OCONEE - 1,2,3

FIELD OPERATIONS SITE PROGRAM REPORT

TITLE (MAX. 30 SPACES) RCV Steam Leak

ROCKWELL VALVES SPR-444 & 461

See photo #2

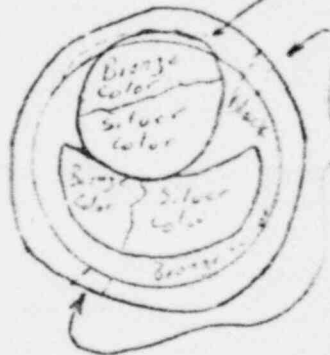
Question: Should the contact area on the end of the stem and the disk nut be of a bearing material? When the valve is back seated this area has force and twist applied and will therefore, have a cutting action if limit switch fails.

a. The bottom of the disk nut shows evidence of wear on the inside diameter surface. *See photo #2*

b. A bronze colored ring was found loose under the disk nut. Thickness was .017 to .030 inches

c. Under stem there is an area which could be the stellite bearing pushed and broken, or it could be the bottom of the stem, $\approx 1/32$ of an inch thick. This piece is pushed into a groove in the body of the disk

DETAIL OF UNIVALVE DISK ARRANGEMENT

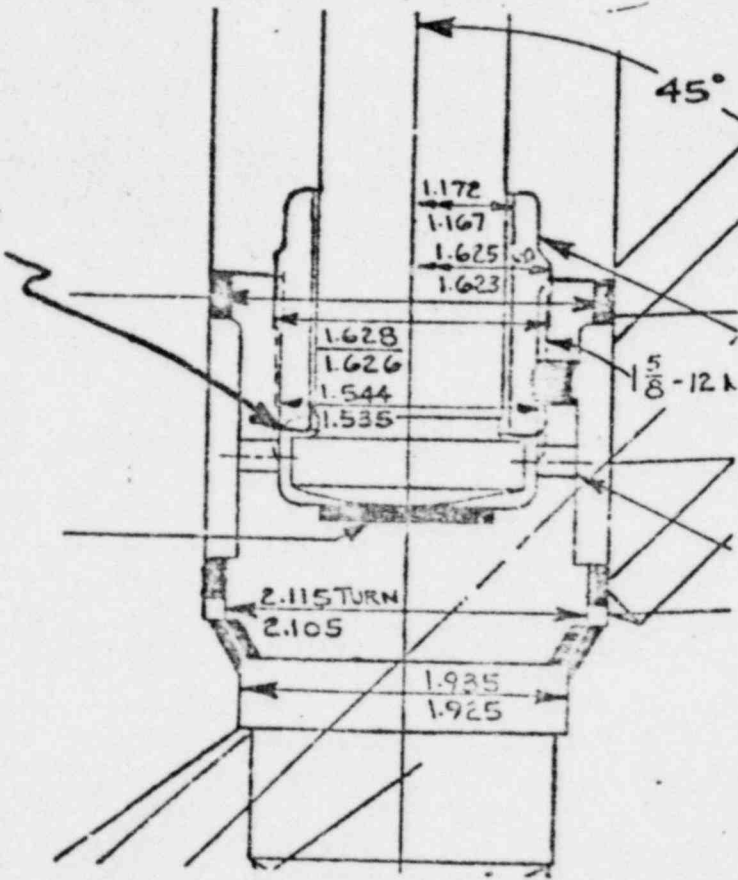
SPR-444 also questioned the backseat design in the stem to disk nut area; the assumption made that the SS stem shoulder rotated against the SS disk nut. Rockwell advises the lower end of the disk nut is in fact stollited (see attachment #1).

Rockwell does not believe it credible that the stem shoulder was only 1/16" thick as was reported in SPR-444. The attached sketch shows the actual size of the component parts and the entire stem is machined from a single piece of bar stock. Based on visual observations by the writer, it appears that the end of the stem was worn away by the grinding action due to repeated

cycling of the valve after initial damage occurred. The two holes in the disk are to prevent pressure buildup in the cavity inside the disk.

B-10752

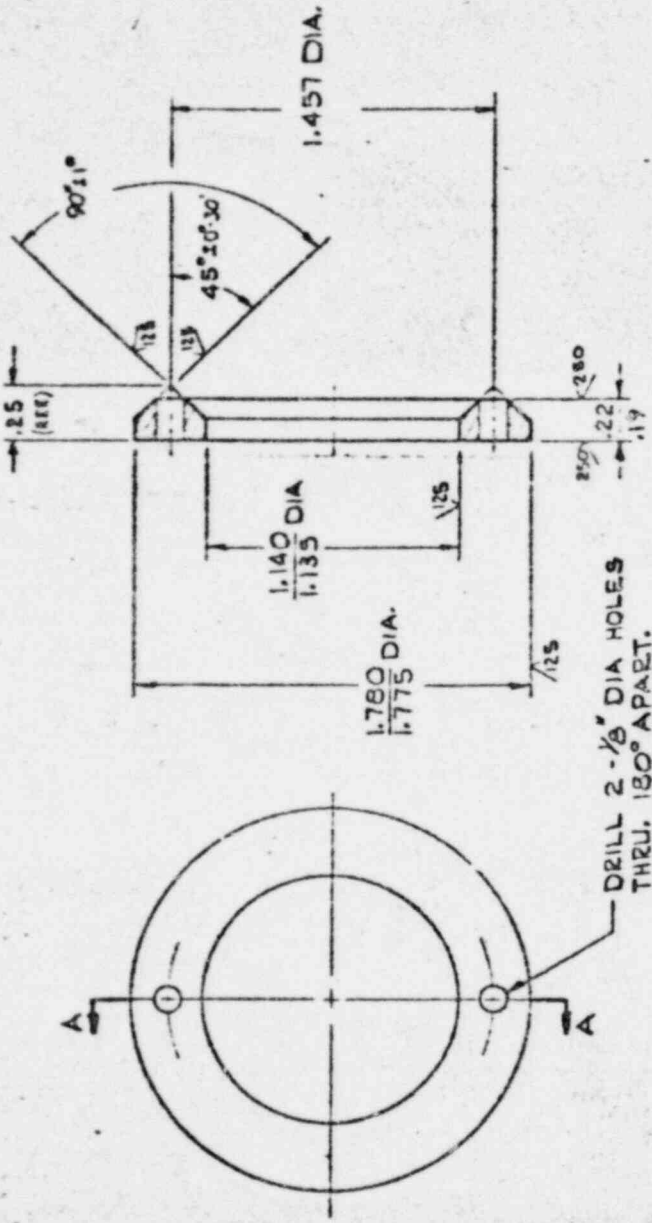
Without question Rockwell agrees that the arrangement as furnished does not allow repacking the lower stuffing box without removing the operators. It is a design error by Rockwell. They have designed a four piece lantern gland to solve this problem. The new Lantern Glands will consist of 2 pieces of the part shown on Rockwell dwg. B-182952 and the split cylinders part shown on dwg. B182953.

3. Replacement parts for RC-V5 are being supplied by Rockwell at their expense since the damage is of indeterminate cause.
4. New lantern glands to allow repacking without removing operators are being supplied by Rockwell at their expense.
